Re: Clawe – Comprehensive Permit Plan Changes

Plan Title:	Lot 1 Septic and Well Plan		
Project Name:	Greenwood Street Homes		
Site Address:	0 Washington St (Map 7, Lot 49) - Sherborn, MA		
Owner:	AB Realty Trust	Client:	Robert Murchison
Project No:	J269-19a	Drawn by:	F.A.
Designed by:	DSW/FA	Approved by:	DSW
Scale:	Indicated		
Rev.:	12/18/23	Leaching field, minor grading around SAS	DSW/FA
Date:	12/05/23	General notes, house and driveway, grading, septic inverts & features	DSW/FA
Description:			
By:	A. Murchison

Plan Title: Lot 2 Septic and Well Plan

Plan Title: Lot 3 Septic and Well Plan

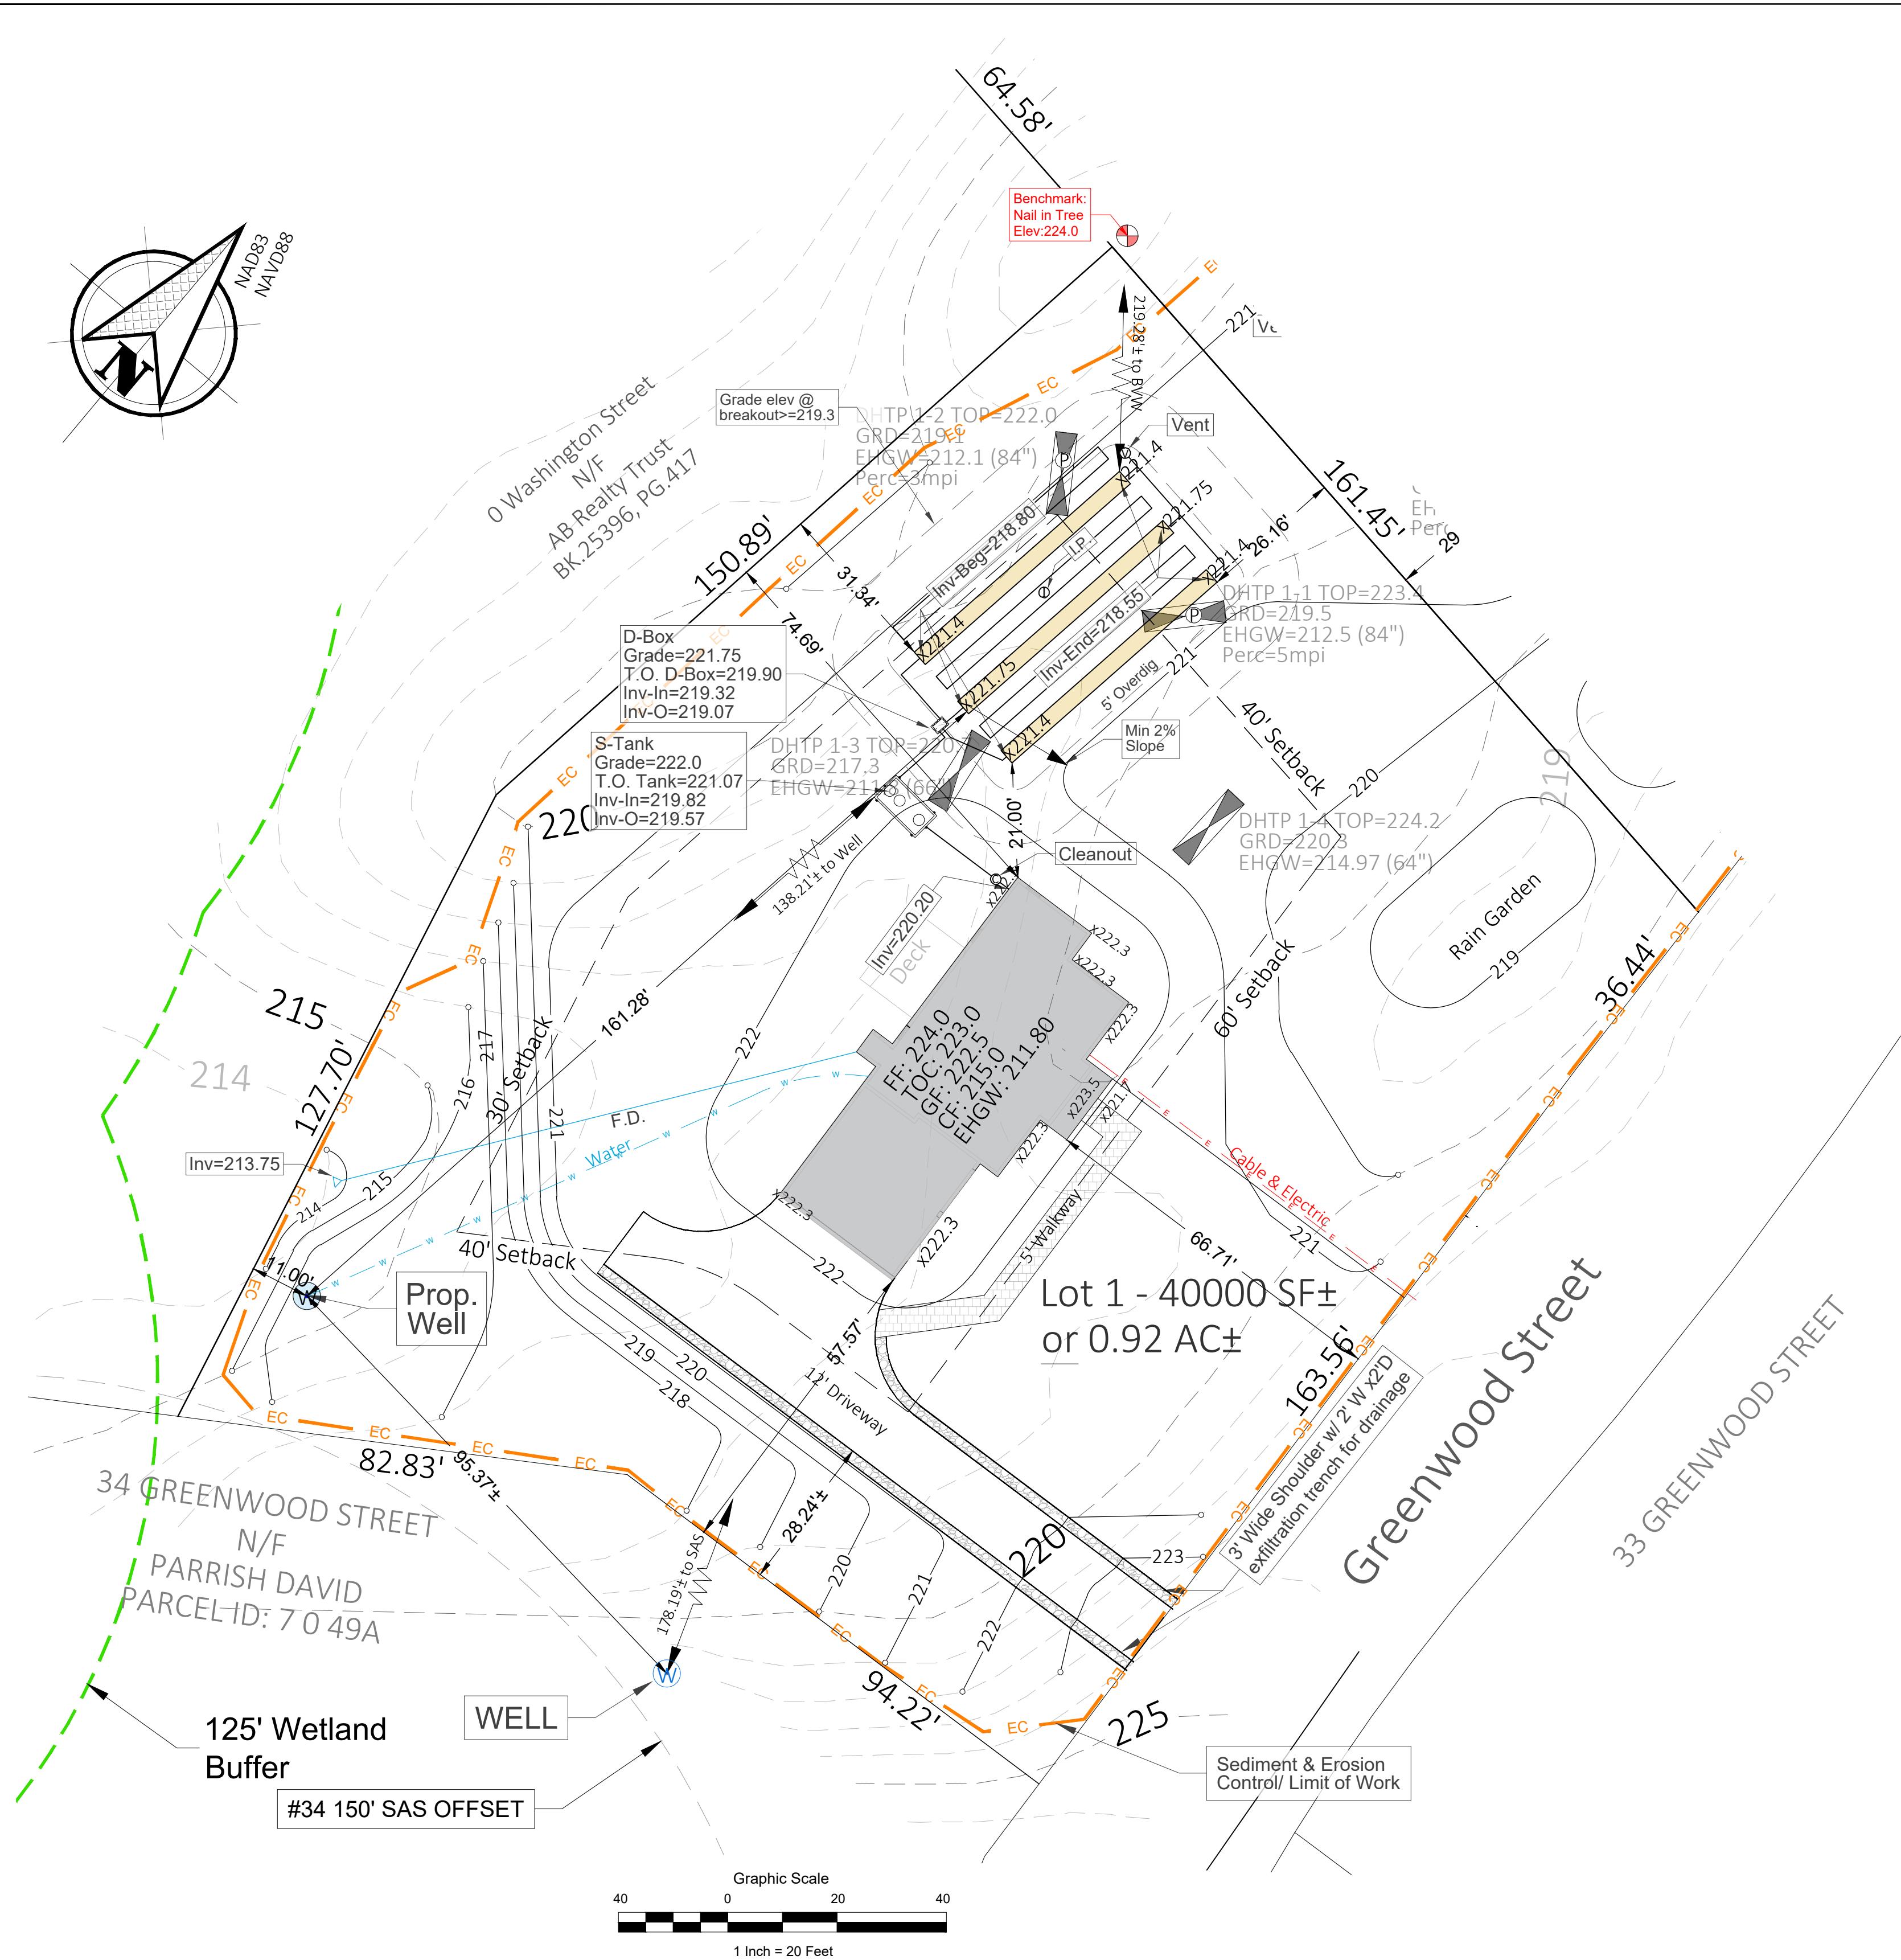
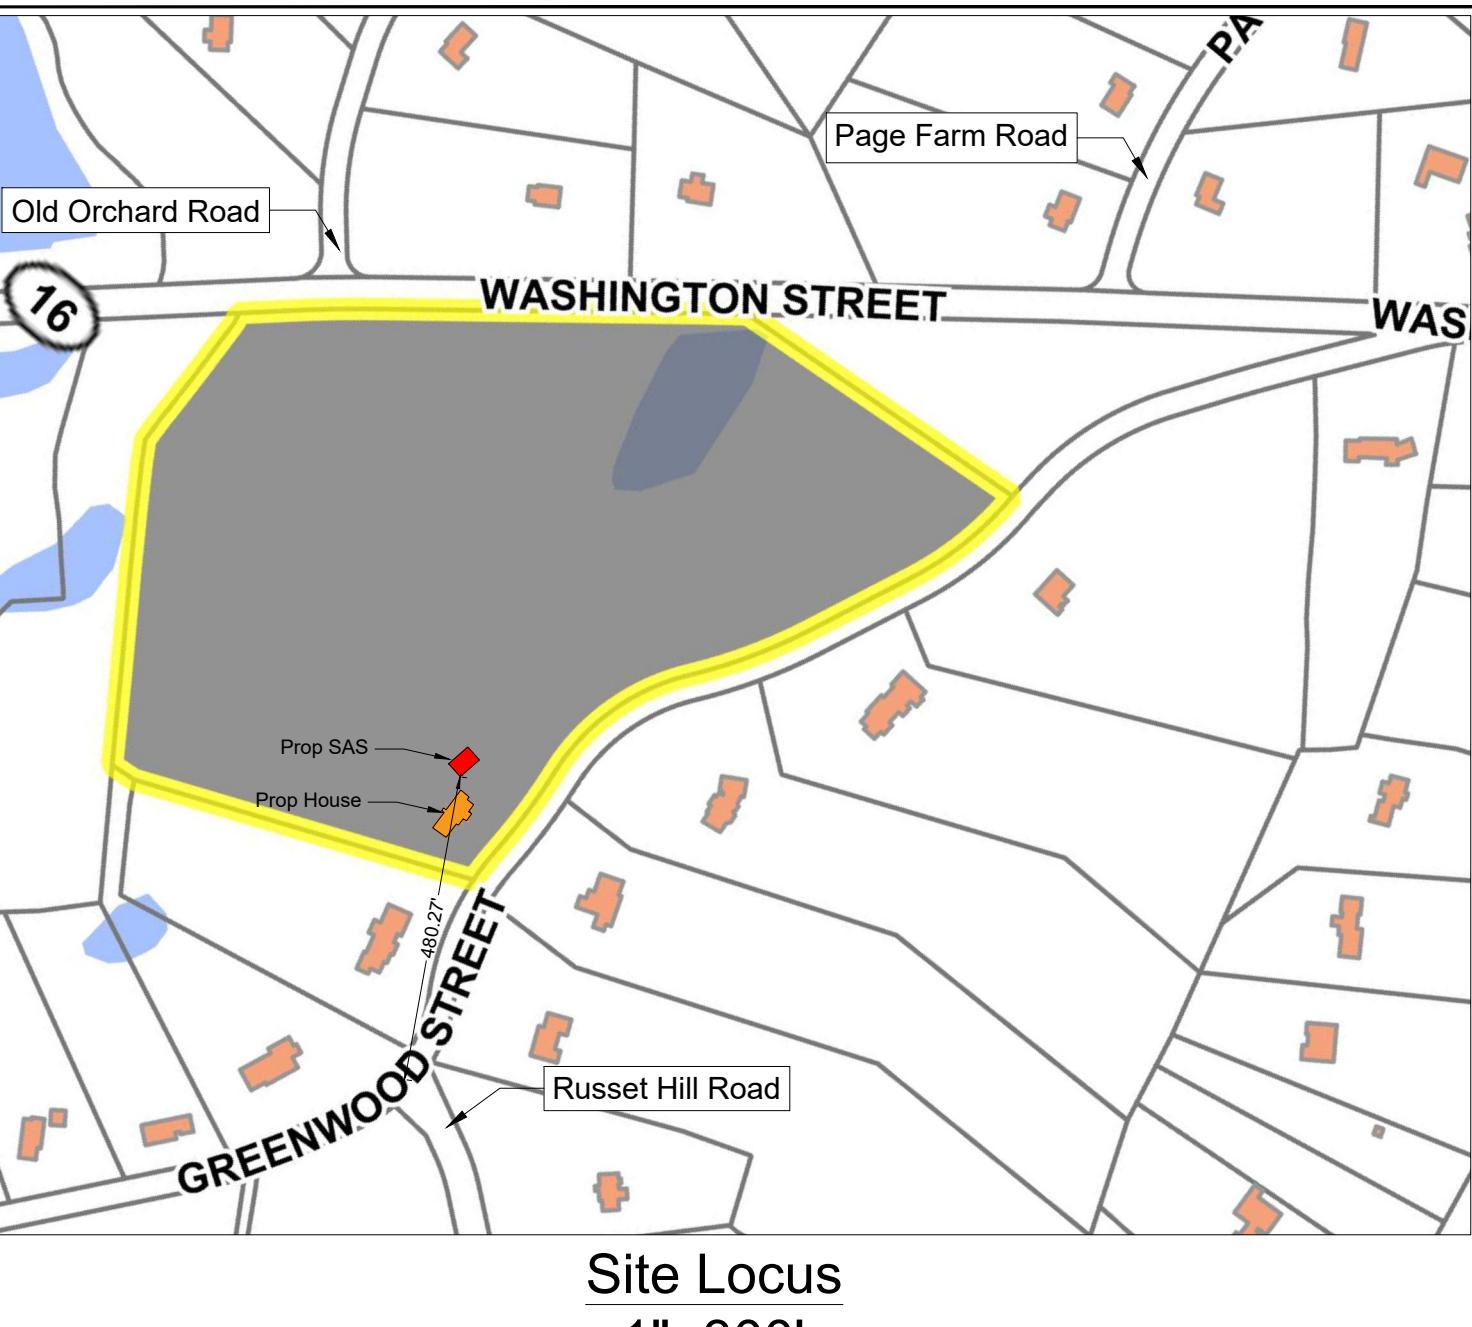
- On Lot 1, the well location shown for the abutting well at 34 Greenwood has been updated to better reflect the “as-built” plan provided by Sherborn BOH recently. Note the location previously shown was a more conservative estimate based on GIS and another BOH record without showing the properly abutting current project land. All required setbacks have been updated.
- On Lot 1, 2 and 3, the SAS has been resized to reflect the Health Agent’s conservative characterization of the soil type as sandy loam. Again, all required setbacks have been updated.
- No Change for Lot 4.

- On Lot 1, the well location shown for the abutting well at 34 Greenwood has been updated to better reflect the "as-built" plan provided by Sherborn BOH. Note the location previously shown was a more conservative estimate based on GIS. All required setbacks have been updated.
- On Lot 1, 2 and 3, the SAS has been resized to reflect the Health Agent's differing characterization of the soil type. Again, all required setbacks have been updated.
